A Review of the Three Mile Island-1 Probabilistic Risk Assessment

Prepared for
U.S. Nuclear Regulatory Commission

A Review of the Three Mile Island-1 Probabilistic Risk Assessment

Manuscript Completed: September 1989
Date Published: November 1989

Figure 1. Nonhurricane and hurricane frequency curves.

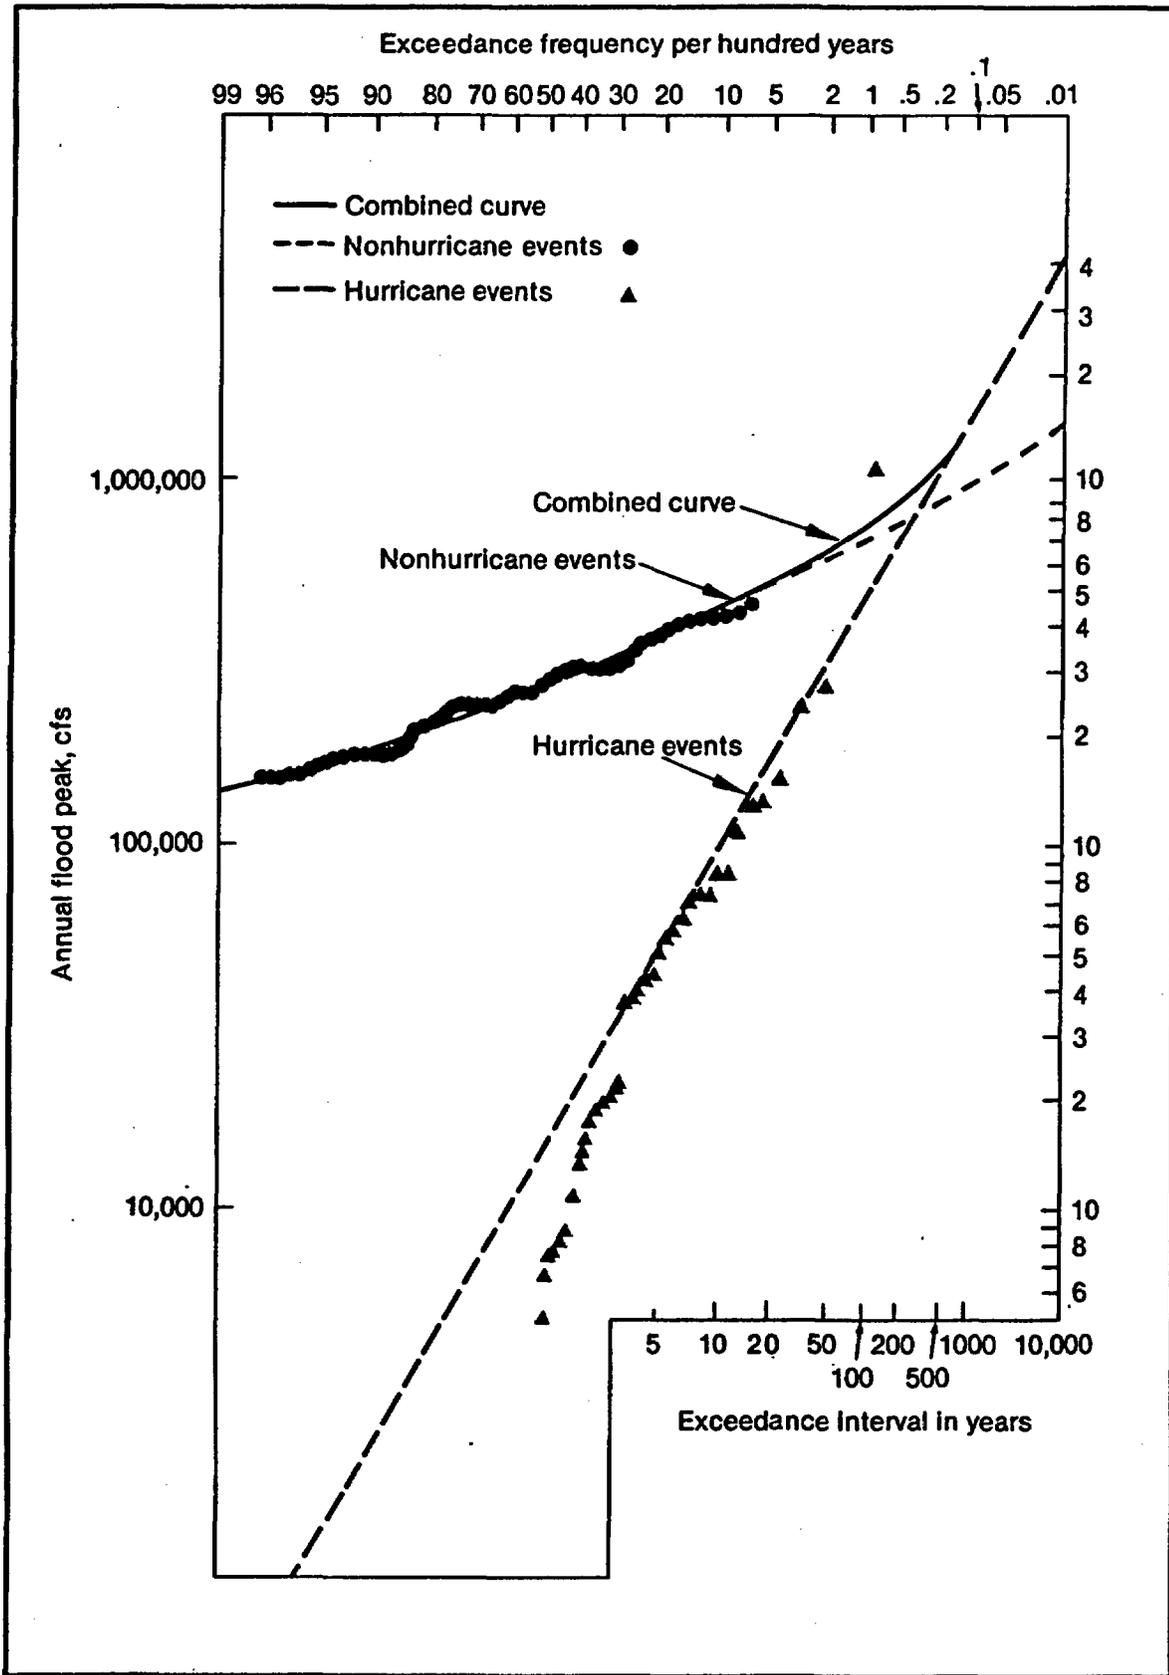
A Corps of Engineers (COE) report prepared in 1975 estimates the frequency of a flood greater than 1,750,000 cfs at Harrisburg to be approximately $7E-04/yr$, based on a figure which is reproduced here as Figure 1.⁴¹ This frequency estimate is based on plotting hurricane and non-hurricane floods separately. The curve drawn through the hurricane flood data has a much steeper slope than that through the non-hurricane flood data. Note that the curve passes below the 1972 flood data point; this feature of the curve is consistent with the methodology recommended for Federal agencies.⁴²

Figure 2. Estimated frequency curve for Susquehanna River at Harrisburg, PA, in accordance with Bulletin 17B.

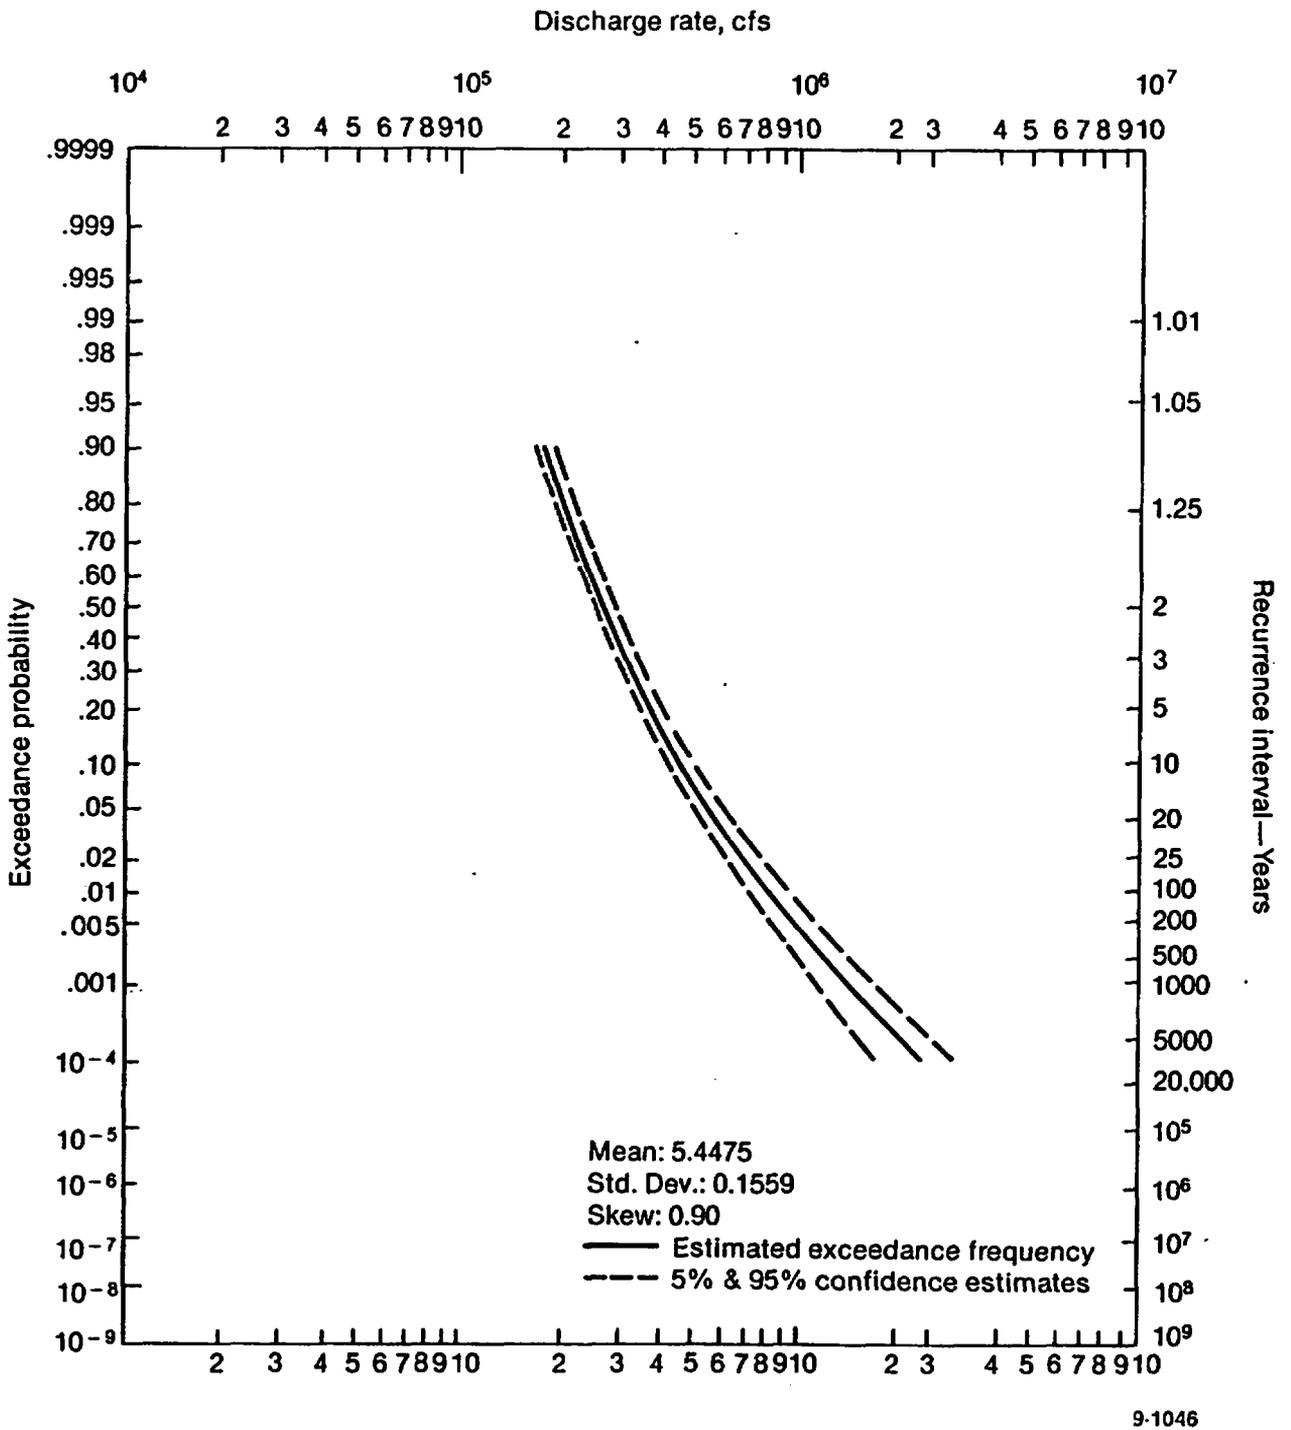
In a personal communication between COE and NRC,^a the COE stated that, using all data up to 1983, they estimated the parameters of such an equation to be \log mean = 5.4475, standard deviation = 0.1559, skew coefficient = 0.90, where units of flow are cfs. This equation predicts the exceedance frequency of the PMF to be about $3.2E-04/yr$, with an uncertainty factor of 5, see Figure 2 (the expected value

corresponding to $3.2E-4/yr$ is $5E-4/yr$, based on Reference 42). Of course, these uncertainty values are valid only if the underlying distribution is Log Pearson III.

It is also appropriate to address the frequencies of core damage due to floods 305–310 ft. These frequencies will be greater than shown in the PRA if the COE equation or the curve of Figure 2 is used—i.e., about $8E-4/yr$. The PRA takes substantial credit for protective actions (early warning, shutdown, installation of cover plates) in the event of a flood 305–310 ft. During the plant visit, the personnel at TMI-1 indicated they did not practise installing the cover plates. The PRA assumed that a hurricane is unlikely to produce the PMF at the site, and that the emergency closure actions (top event SL) could be considered routine (sufficient time) rather than dynamic. However, it appears to us that the PMF is more likely to be produced by a hurricane. It seems the approach of the hurricane-induced flood, with the emergency closure taking place, would be accompanied by loss of offsite power along with heavy rain and high winds on site. The personnel would have one chance to make proper installation because after the arrival of high water, the island would be flooded, leaving little if any chance to correct any deficiencies. The PRA estimates the human error rates with a recovery factor of 0.19 to account for potential recovery in the event any steps in the emergency closure (top event SL) have failed. Our review indicates that the human response analysis results would not be changed for the decrease in warning time that would be involved in a hurricane-caused PMF. The human response analysis did not consider the likelihood of a cover plate or air-inflatable seal being defective and nonrepairable within the available time. The PRA may be optimistic in this regard. However, on a best estimate basis, the floods 305–310 ft are not as important as those above 310 ft.

Figure B-1. Annual frequencies of loss of offsite power (LOP) exceeding a time T. (Review Estimates)

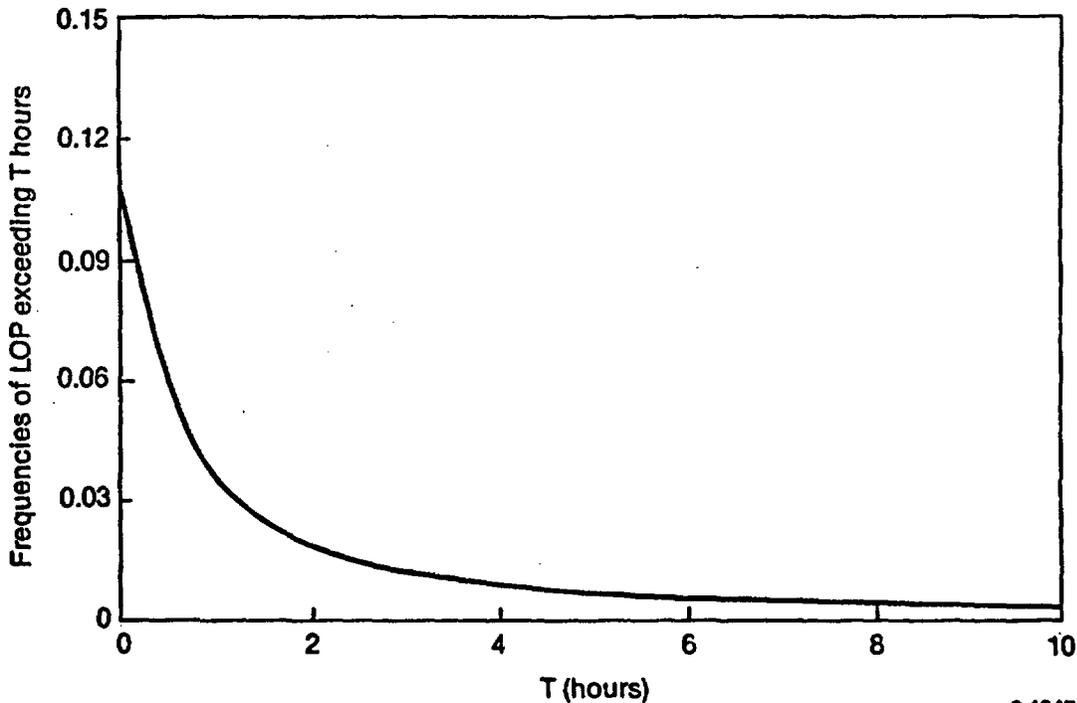
Figure B-1 gives the frequency of losses of offsite power exceeding a duration t, as calculated from the above expressions.

Figure C-1. TMI plant fragility curve.

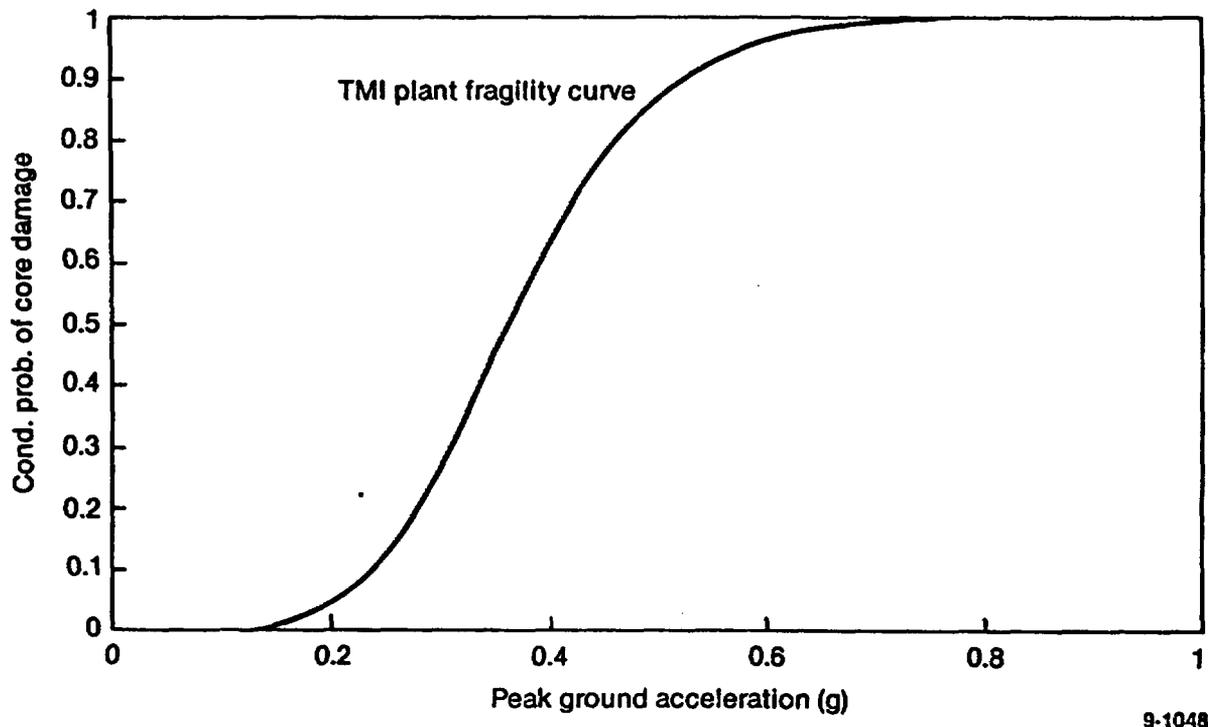
The quantity $\text{pr}\{S1 + S2 + S3 | a\}$ is the conditional probability of core damage given a pga of a. When considered as a function of a, it is sometimes called the plant fragility curve. The mean plant fragility curve is displayed in Figure C-1. One sees that there is about a 50% chance of core damage, given a pga of 0.36g. Since the Safe Shutdown Earthquake (SSE) corresponds to 0.12g for the pga, there is a 50% chance of core damage at about 3 times the SSE pga. Typically the 50% point on the plant fragility curve is between twice the SSE and four times the SSE, so the results for TMI are not unusual.
